**TO: HONORABLE CHAIRMAN AND PLANNING COMMISSION**  
**FROM: RON WHISENAND, COMMUNITY DEVELOPMENT DIRECTOR**  
**SUBJECT: PLANNED DEVELOPMENT 07-007 (HOMETOWN NURSERY)**  
**DATE: JULY 24, 2007**

**Needs:** For the Planning Commission to consider an application filed by Nick Gilman on behalf of Dr. B.R. Bryant for PD 07-007 proposing to develop a new site for Hometown Nursery.

Vicinity Map  
PD 07-007  
(Hometown Nursery)

**Exhibit B**  
**Site Plan**  
**PD 07-007**  
**(Hometown Nursery)**

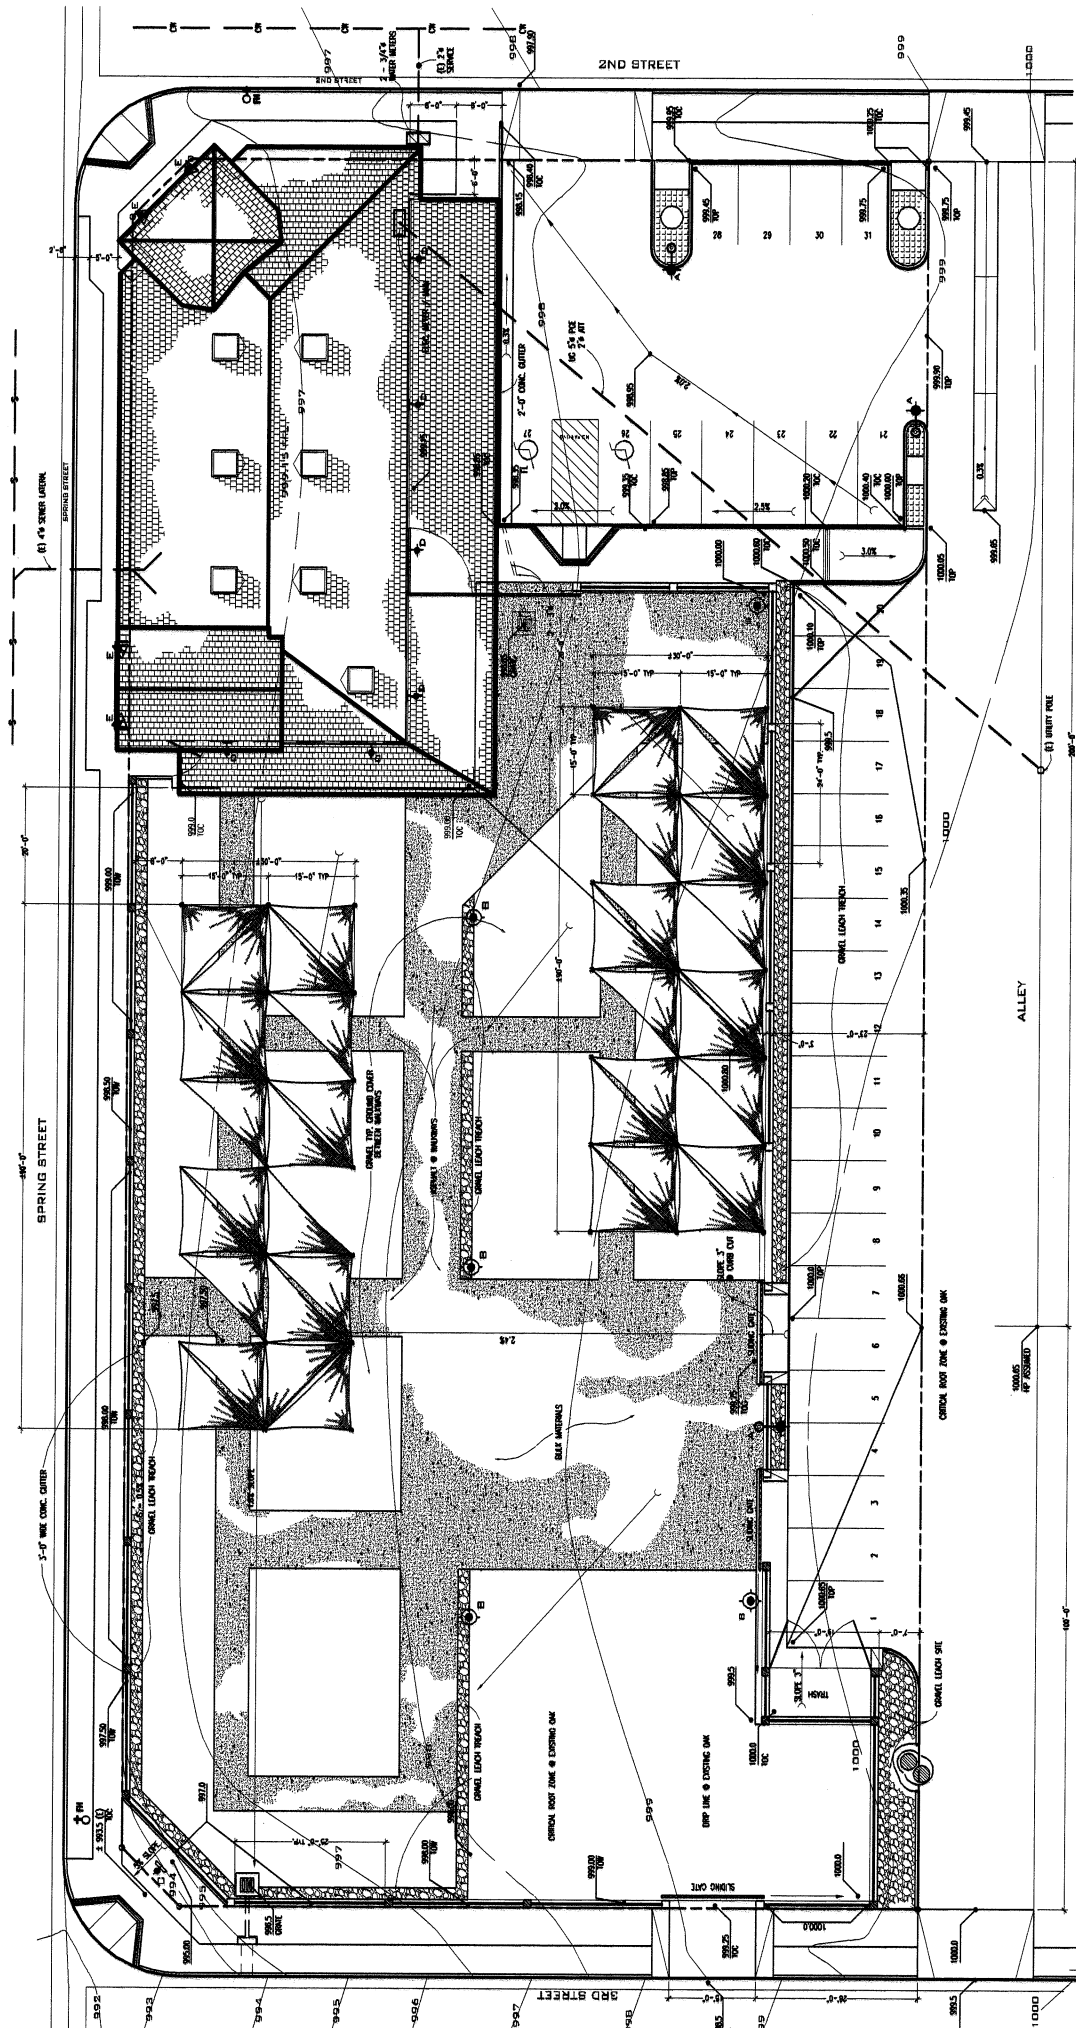
6. The site gradually slopes down to the north and in order to provide a relatively flat area for the outdoor sales area, the plans show the construction of retaining walls approximately 3-feet in height.

- Articulation in the Spring Street retaining wall & decorative fencing to allow for periodic planting between the wall and sidewalk;
- Inclusion of alternative building materials such as brick or other type of wainscot material;

**Exhibit E**  
**Fence/Wall Details**  
**PD 07-007**  
**(Hometown Nursery)**

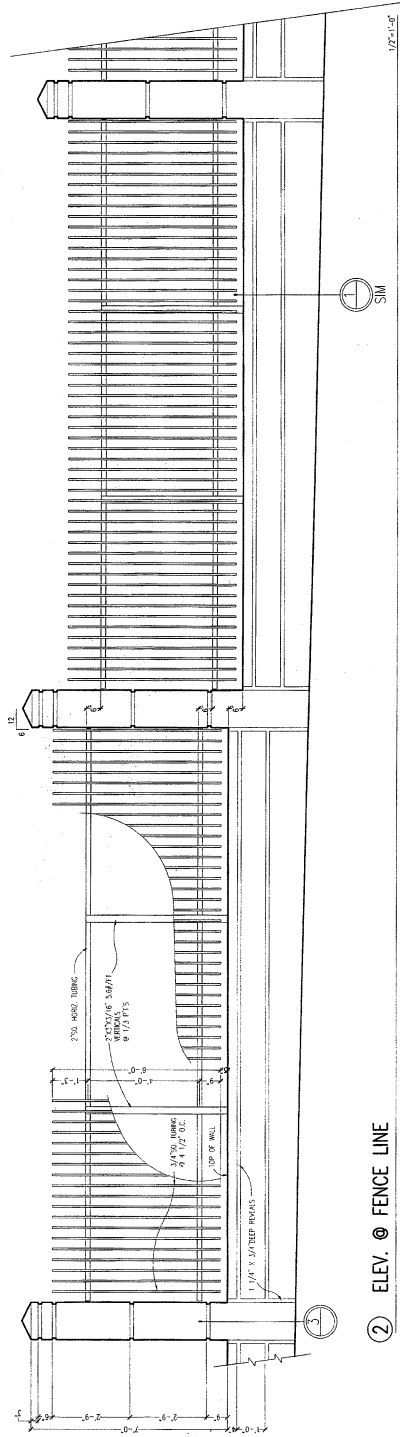
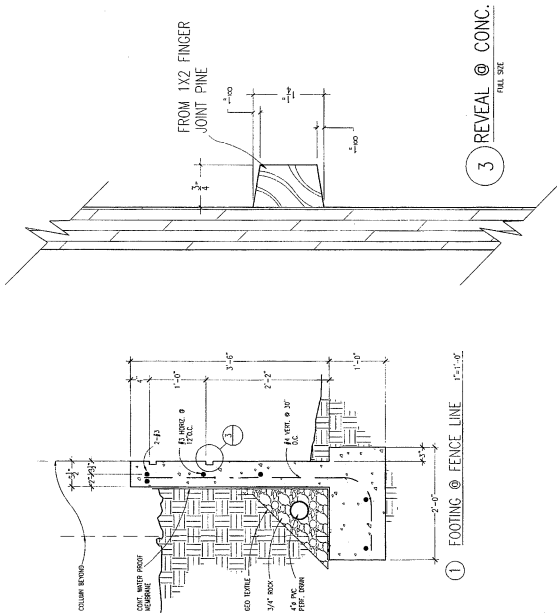
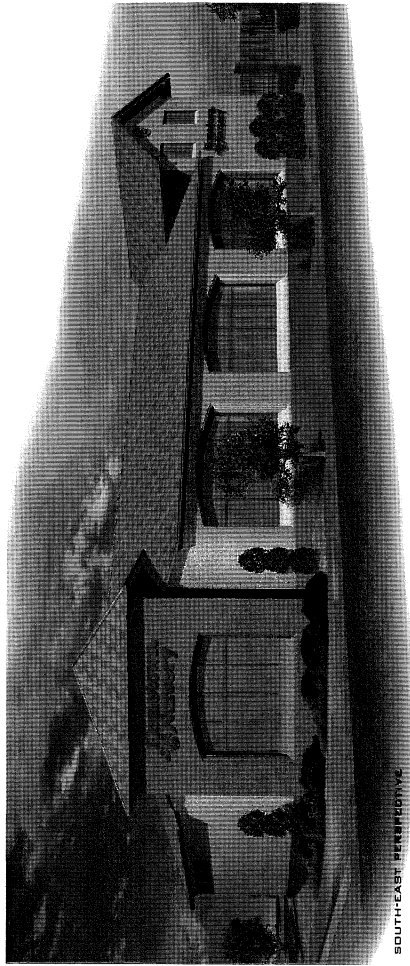
7. Decorative fencing would be constructed around the outdoor yard area and would be incorporated into the retaining walls. Fencing materials include black tubular steel with concrete pilasters.
